Response to SDG&E Technical Questions dated February 8, 2008

**Comments on the Administrative Draft of the Sunrise Powerlink EIR/EIS
Colorado Desert District
CA Department of Parks and Recreation
July 5, 2007**

Proposed Routes for Sunrise Powerlink

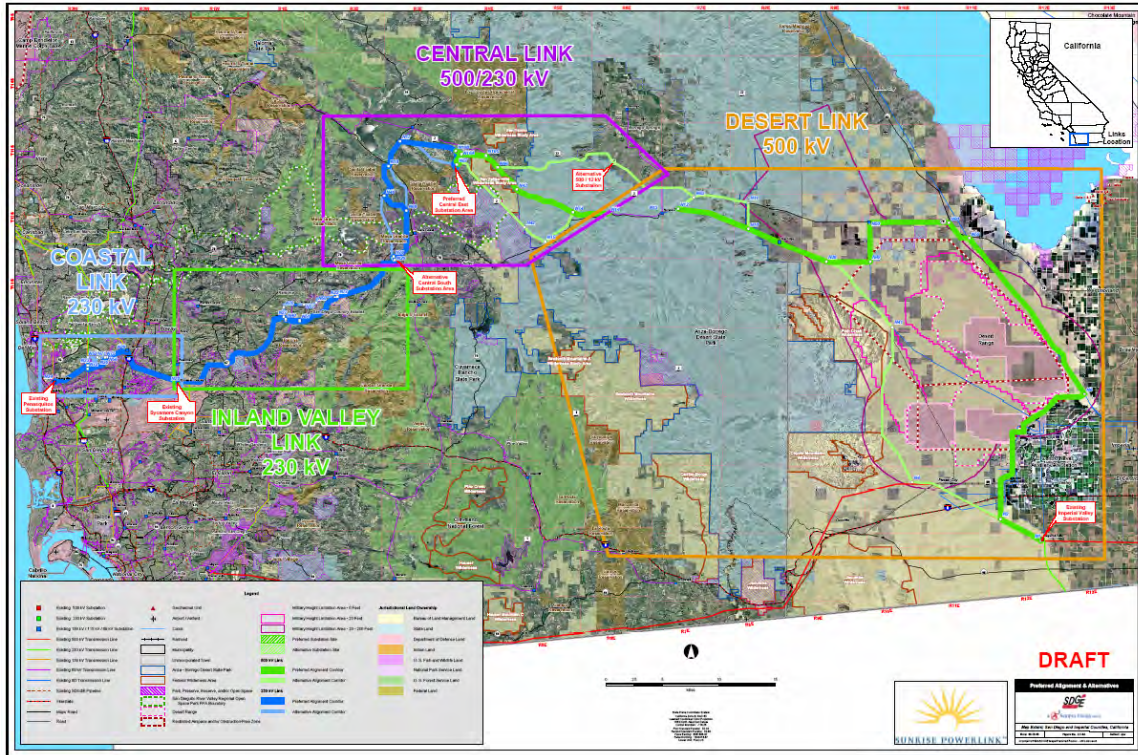
1. Please provide the maps referenced in the July 13, 2006 letter sent by BLM to the tribes and included in Appendix 9C of the Draft EIR/EIS.

Response: The maps referenced in the BLM tribal consultation letter of July 13, 2006 included Figure 2 3-1A from SDG&E's Administrative Draft PEA of June 21, 2006 (denoted as the updated map in the text of the letter) and a SDG&E map from early 2006. Each is shown on the following page. The "corrected map" is the one shown first (sent on July 13); the map that BLM included in the original mailing is the one shown second (sent on July 5 and showing the Desert Western route).

Maps Provided with September 5, 2007 Tribal Mailing

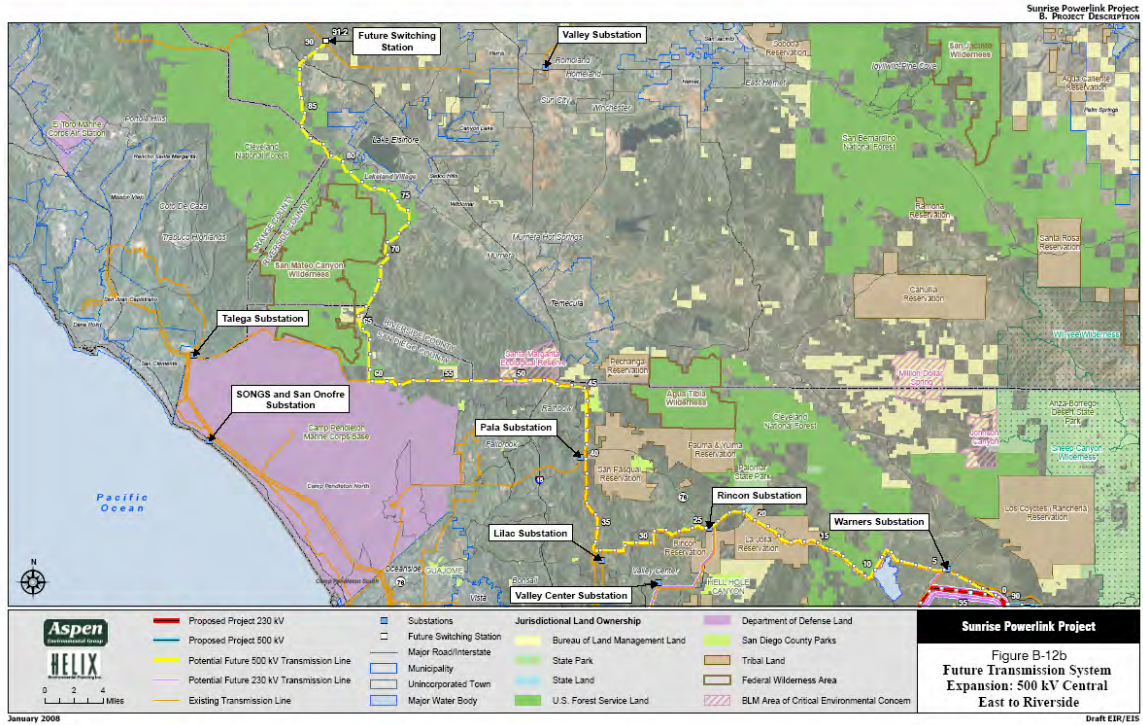
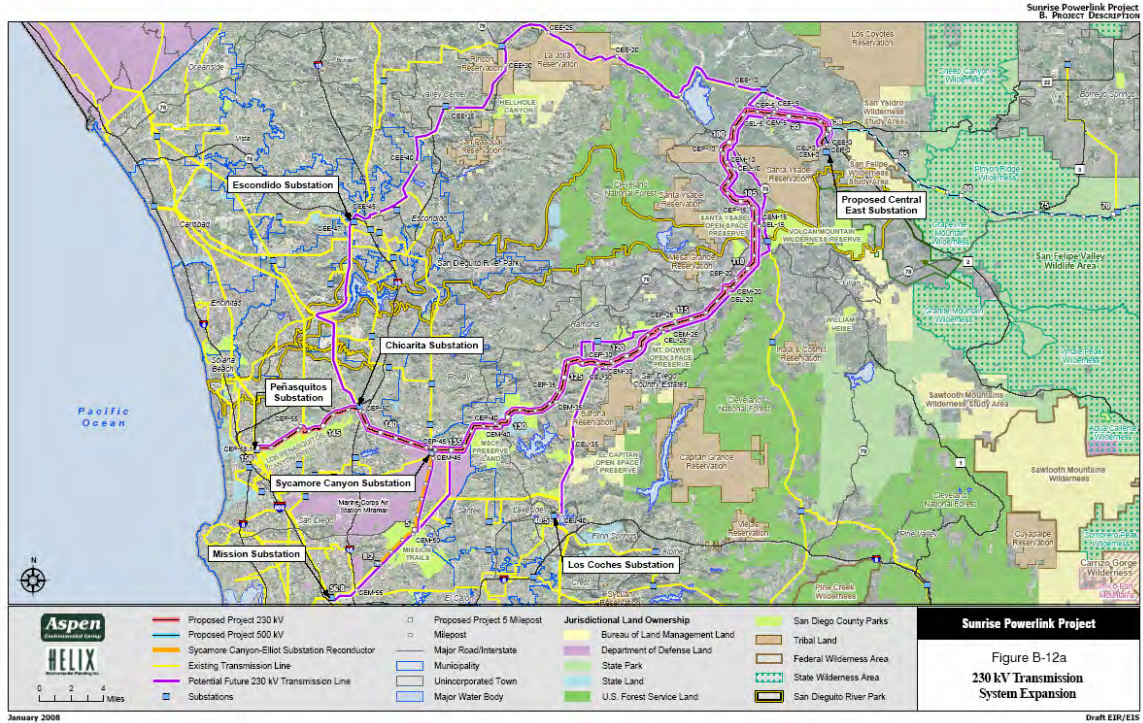
2. Please provide the maps referenced in the September 5, 2007 letter sent by BLM to the tribes and included in Appendix 9C of the Draft EIR/EIS.

Response: The BLM tribal consultation letter of September 5, 2007 included the Draft EIR/EIS Figures B-12a and B-12b, shown on page 3. These maps were titled "230 kV Future Transmission System Expansion" and "500 kV Future Transmission System Expansion", rather than Figures B-12a and 12b when they were supplied to the tribes.
